NUMBER 110

# BULLETIN

SUBJECT: WINDSHIELD ATTACHMENT

MODELS AFFECTED: PIPER AIRPLANES MODELS PA-15 SERIAL NUMBERS 15-1 TO 15-387 INCL., AND PA-17 SERIAL NUMBERS 17-1 TO 17-214 INCL.

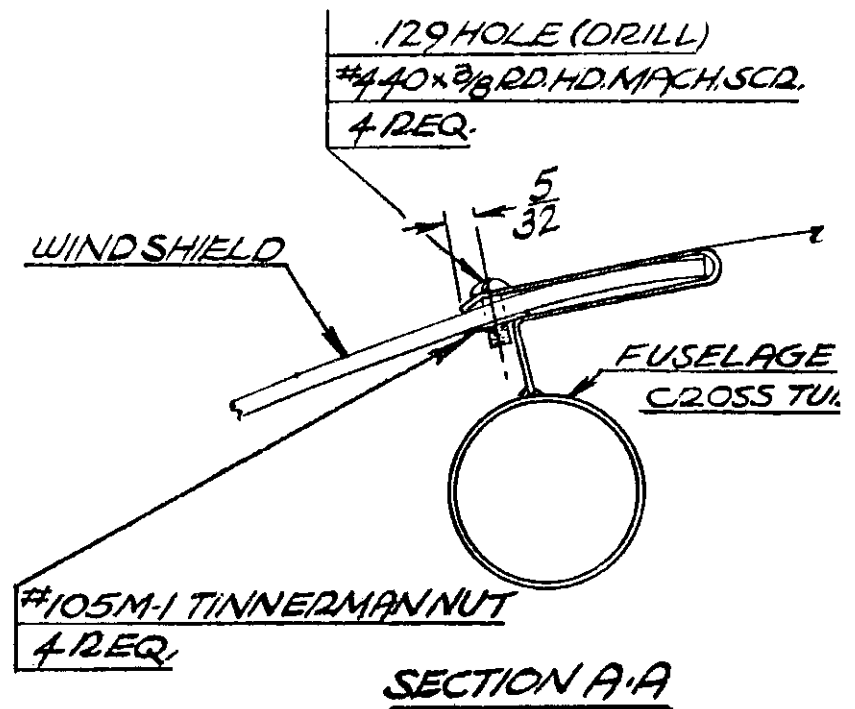
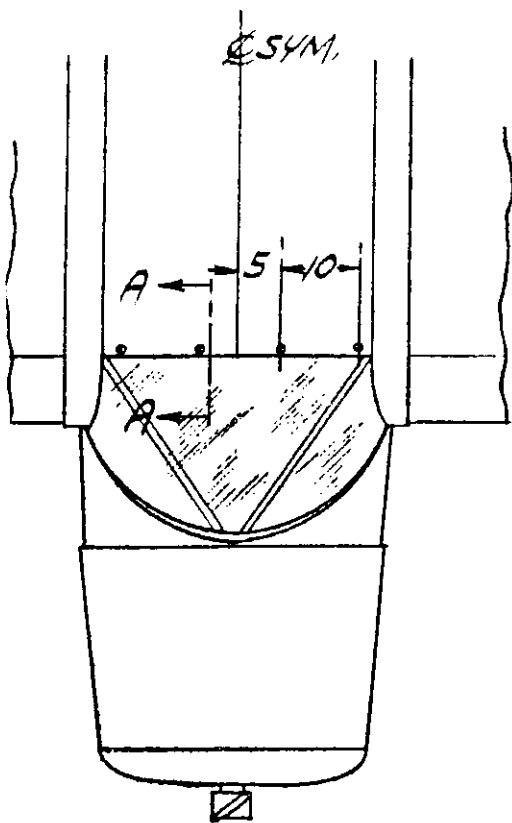
In order to eliminate the possibility of the windshield coming out of its top retaining channel (channel located on tube between front wing hinge fittings) it is strongly recommended that the windshield attachment be reworked to incorporate the use of four machine screws installed in accordance with the sketch below.

DO NOT FORCE DRILL THRU PLEXIGLAS
